ORDINANCE NO. 2484

AN ORDINANCE REPEALING AND REPLACING CHAPTER 5, ARTICLE IV, DIVISION 6 OF THE COMMERCE CITY REVISED MUNICIPAL CODE WHICH DETAILS THE ADOPTION OF THE 2021 INTERNATIONAL PLUMBING CODE (IPC) WITH STATE-MANDATED AMENDMENTS

**FIGURE 802.1.6.2
DISHWASHER DRAIN**

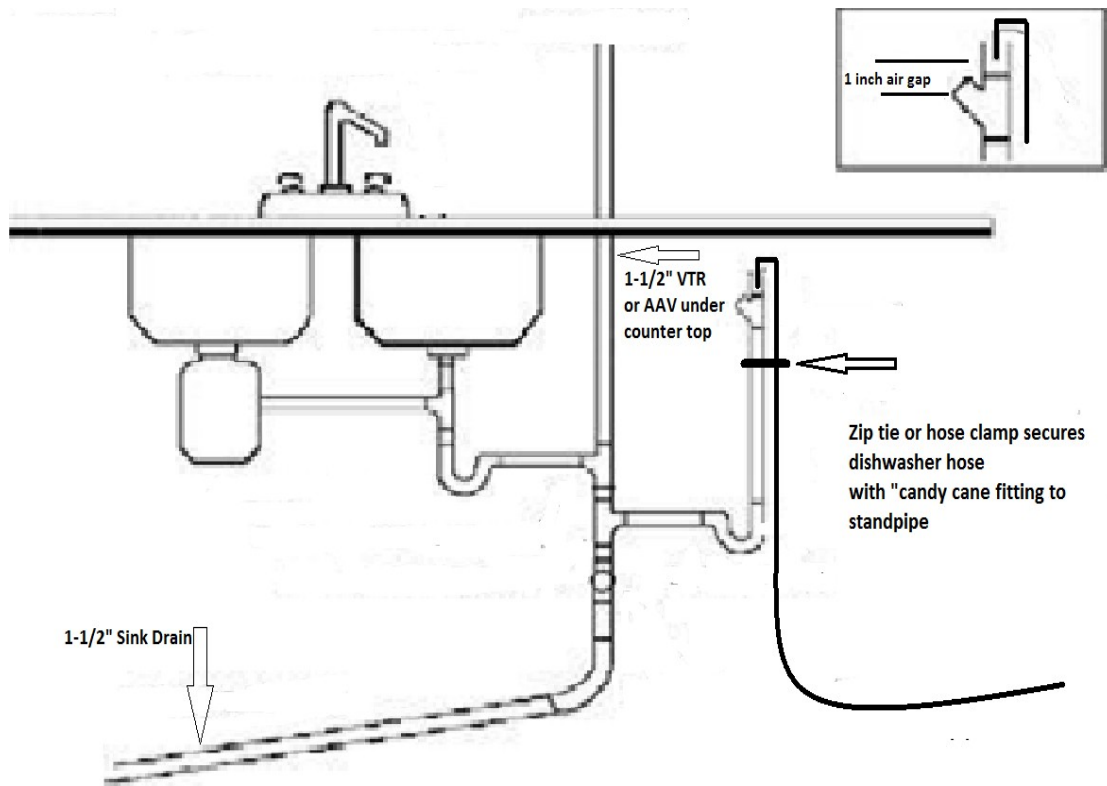
- (zz) *Section 802.1.6.2, entitled “Domestic dishwashing machines,” is added to read as follows:*

802.1.6.2 Domestic dishwashing machines. Domestic dishwashing machines may be connected to a separately trapped stand pipe provided with an air break (with drain hose secured to the underside of the counter top) or air gap as shown in Figure 802.1.6.1.2. See Section 409.4 for additional waste connections.

FIGURE 1302.1.1 TYPICAL GRAYWATER COLLECTION SYSTEM
(This figure is typical only, not a schematic)

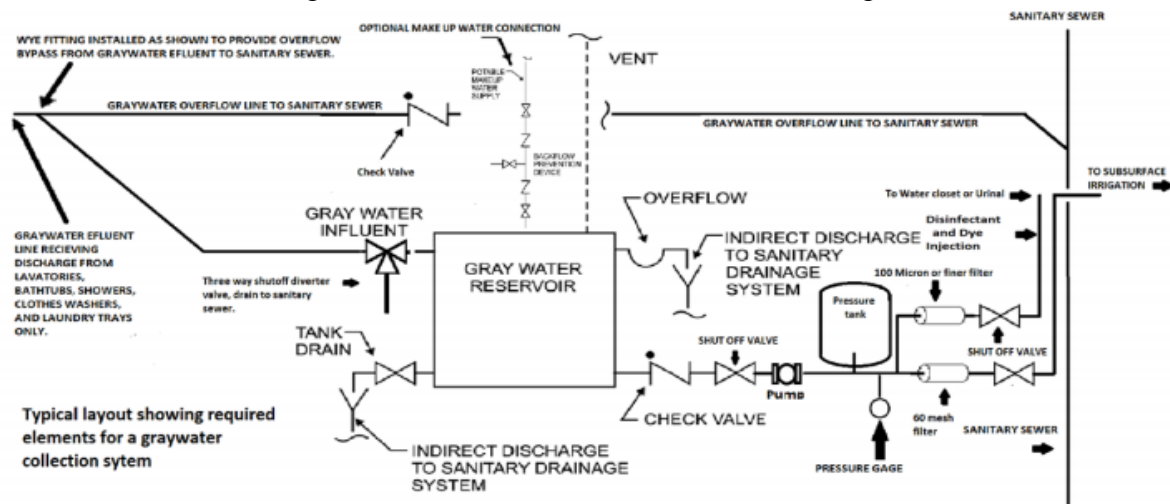
(rrr) Section 1302.1.1, entitled "Typical graywater collection systems," is added to read as follows:

1302.1.1 Typical graywater collection systems. Graywater collection systems shall be designed and constructed in accordance with Figure 1302.1.1.

FIGURE 1302.1.2 TYPICAL GRAYWATER SYSTEM FOR TOILET AND URINAL FLUSHING
(This figure is typical only, not a schematic)

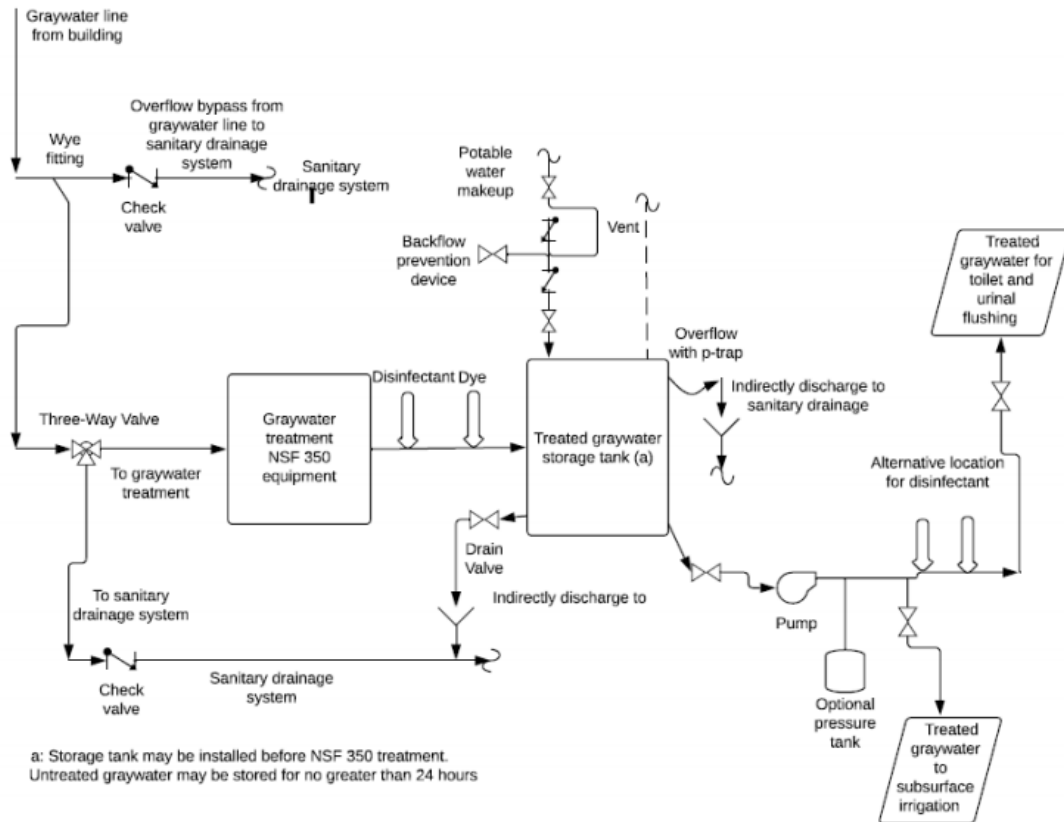
(sss) Section 1302.1.2, entitled "Typical graywater system for toilet and urinal flushing," is added to read as follows:

1302.1.2 Typical graywater system for toilet and urinal flushing. Graywater systems for toilet and urinal flushing shall be designed and constructed in accordance with Figure 1302.1.2.

**FIGURE 1302.1.3 TYPICAL GRAYWATER SYSTEM FOR DISBURSED
SUBSURFACE IRRIGATION**
(This figure is typical only, not a schematic)

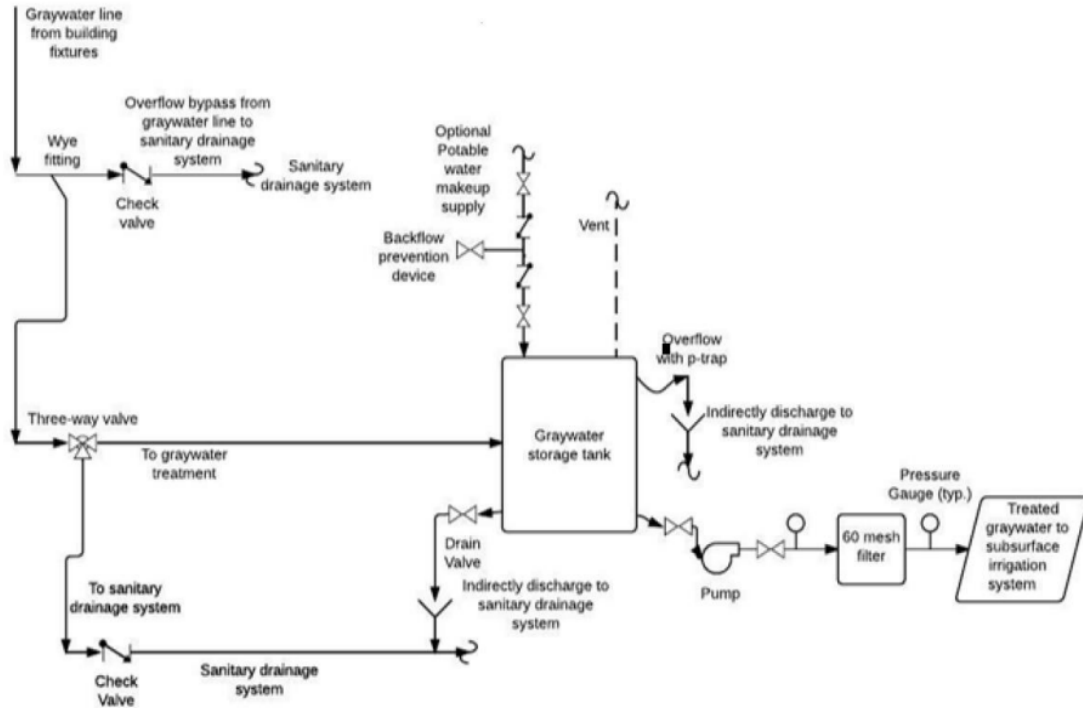
(ttt) Section 1302.1.3, entitled “Typical graywater system for disbursed subsurface irrigation,” is added to read as follows:

1302.1.3 Typical graywater system for disbursed subsurface irrigation. Graywater systems for disbursed subsurface irrigation shall be designed and constructed in accordance with Figure 1302.1.3.

FIGURE 1302.1.4 TYPICAL GRAYWATER SYSTEM FOR MULCH BASIN SUBSURFACE IRRIGATION
(This figure is typical only, not a schematic)

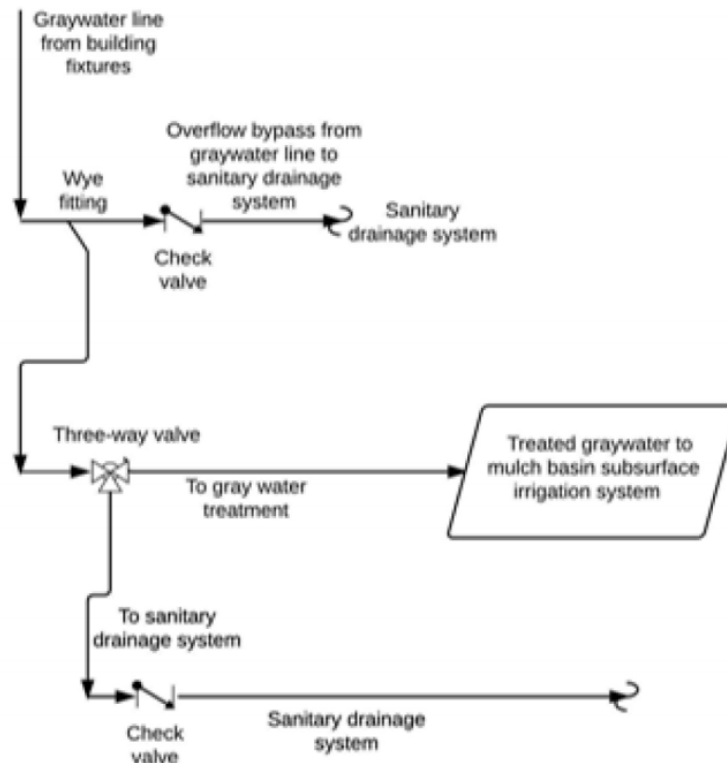
(uuu) *Section 1302.1.4, entitled “Typical graywater system for mulch basin subsurface irrigation,” is added to read as follows:*

1302.1.4 Typical graywater system for mulch basin subsurface irrigation.

Graywater systems for mulch basin subsurface irrigation shall be designed and constructed in accordance with Figure 1302.1.4.
